July 5, 2006

Regarding: 10" Bin Flange used with 10" Chain Loop Systems

NEW 10" Bin Flange
for 10" Chain Loop Systems
8101318

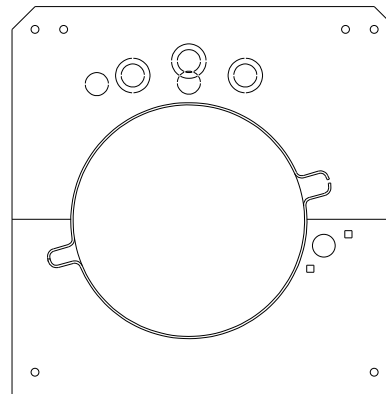
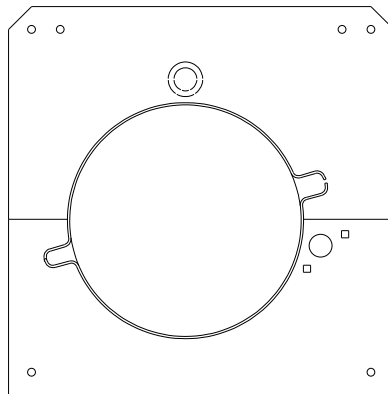
It was brought to my attention that there are alignment issues with the current 10" Bin Flange (GK1056) when used with the 10" Chain Loop Intermediate & center wells. To correct this problem, I have created a new 10" Bin Flange (**8101318**) to be used with the 10" Chain Loop System. The new number is effective immediately.

The new 10" Bin Flange **8101318** offers 1.00" & 1.50" knockouts for well gate control rods. The price will remain the same at \$48.54.

In the price catalog, 10" Chain Loop Section under Accessories, please replace GK1056 with **8101318**.
